Attachment 1: Ontario Line Alignment

Attachment 2: Recommendations

AREAS 1, 2, 3, & 4: LOWER DON RIVER

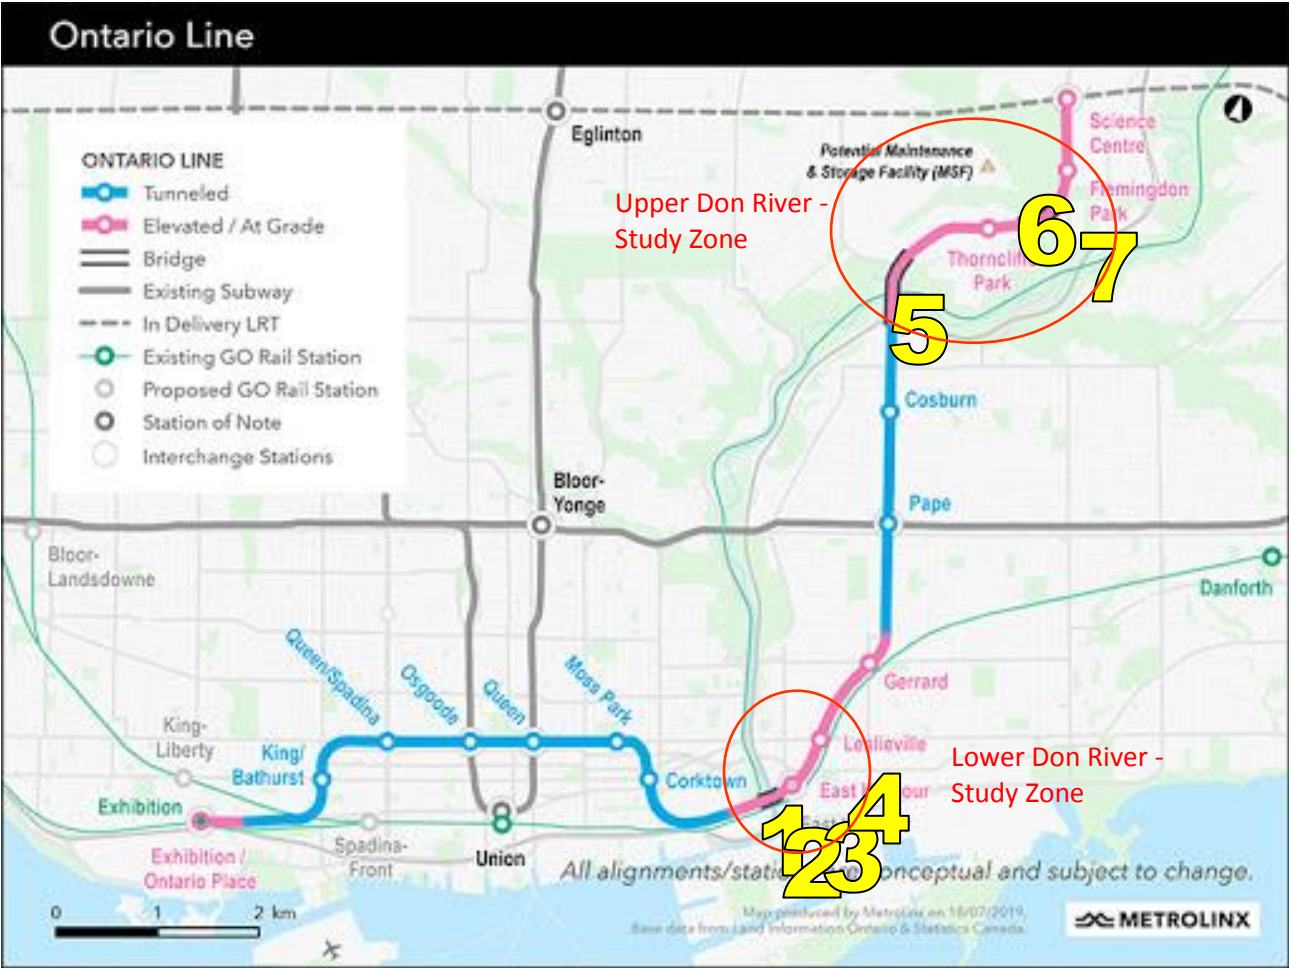
1. TRCA staff review the high-level Mike Flood 2D floodplain impact study to confirm that there are no additional flood plain impacts resulting from the Richmond Hill corridor works.

2. Metrolinx demonstrate that no temporary or permanent infrastructure, alterations, or construction and temporary excavations will be within 10 metres of the WDFPL footprint. If disturbance is unavoidable, Metrolinx will demonstrate that all other alternatives are not feasible to TRCA's satisfaction.

3. Metrolinx to enter into an agreement with TRCA that:
 - a. Metrolinx adopts measures to mitigate impacts to the FPL to the satisfaction of TRCA.
 - b. Metrolinx restore the WDFPL to original design standard or better post construction; TRCA will review and confirm the appropriateness of the restoration.

- c. TRCA review and approve any changes to the tie in point of the WDFPL, if needed.
 - d. Metrolinx undertake long-term monitoring to confirm that the long-term function of the FPL is appropriately maintained after the proposed alterations, to the satisfaction of TRCA. Metrolinx will additionally be required to undertake all necessary remedial and mitigative measures, if deemed necessary as per the monitoring results, to the satisfaction of TRCA.

4. Metrolinx confirm TRCA property requirements early in the process to begin the easement.

5. Metrolinx confirm the timing of constructing the Lower Don River crossing. If the timing of construction is before the proposed EHFPL and potential flood remediation works resulting from the BEFP Municipal Class EA north of the rail embankment, Metrolinx will need to proactively design to incorporate with future flood protection as well as provide temporary flood protection measures for their project in accordance with provincial hazard and TRCA policy.
6. Metrolinx engage with TRCA and its partners to review the flood protection strategy for this project, including optimizing project solutions, timing and funding to construct the required protection measures in advance of the funding for the permanent infrastructure.

7. Metrolinx provide more details regarding the proposed East Harbour Station works in the Early Works Report. TRCA should be provided with sufficient time to review the full extent of the proposed works, prior to completion in accordance with the TRCA-Metrolinx SLA. Metrolinx should incorporate TRCA comments into the document prior to public review; however, if Metrolinx is unable to address TRCA comments at this stage, commitments to address comments through the VPR process should be added to the reports or provided in a separate memo.

8. Metrolinx partner with TRCA, the City of Toronto, and Waterfront Toronto to secure funding for flood protection infrastructure for the northern section of this area.

9. Metrolinx update the Early Works report to include the following: a) details on how the East Harbour Station interfaces with the DMNP, Broadview Underpass, Gardiner Expressway and Lakeshore Boulevard Realignment, and Broadview Avenue Extension; and b) potential effects and mitigation measures resulting from these studies.

10. Unless the flood proofing infrastructure to the south and north of the East Harbour Station embankment are implemented, the agency responsible for flooding impacts should be determined prior to construction and/or added as a commitment in the Early Works report.

11. Metrolinx conduct a geotechnical and stability review of proposed alterations as a result of the earthworks for the alignment and to assess the impact of the proposed alterations on the valley slope stability and to develop the appropriate mitigation strategy against potential erosion hazard for the valley slopes at the crossing.

12. Metrolinx identify the potential constraints on replantation of the altered areas by grading or engineering the slope for stabilization purposes as well as the permanent impacts on the ecosystem in the valley slope area.

13. Metrolinx consider a new bridge, adjacent to the Leaside Bridge that can accommodate a railway system, similar to the Bloor Street Viaduct.
14. Metrolinx undertake a more detailed natural heritage inventory and impact assessment to estimate a more up-to-date ecological impacts of the proposed alignment and to inform appropriate mitigation measures.

15. The footprint of the alterations and total piers should be reduced as much as possible allowing for optimal connectivity in the valley.
16. The proposed station in the vicinity of any crossing near the valley system should have active transportation amenities (safe pedestrian connections, lighting, lit crossings, bike parking, bike wash stations, etc.) to promote active transportation as a safe first mile/last mile option for public transit.

17. Metrolinx commit to conducting the slope stability study for this site (valley slopes on north/northeast and south) at this stage of the process to inform the feasibility study and to develop the options. This will include LTSTOS (with additional 6-10 m buffer) and grading information for the proposed works (including temporary), so that the extent of the disturbance as well as the appropriate mitigation strategy from the long-term erosion and slope stability hazards are identified.
18. Metrolinx to provide TRCA staff with the design criteria and conditions for the PSOS for review and approval to ensure that TRCA requirements to mitigate the erosion hazard, as well as to protect the slopes and ravines, are met.

19. Metrolinx commit to conducting the slope stability study for this site (valley slopes on both sides of crossing and the parallel segment) at this stage of the process to inform the feasibility study and to develop the options. This will include LTSTOS and grading information for the proposed works, so that the extent of the disturbance as well as the appropriate mitigation strategy from the long-term erosion and slope stability hazards are identified.
20. Metrolinx submit a hydraulic assessment memorandum with the latest Don HEC-RAS model which demonstrates that there are no flood plain impacts with the proposed crossing.
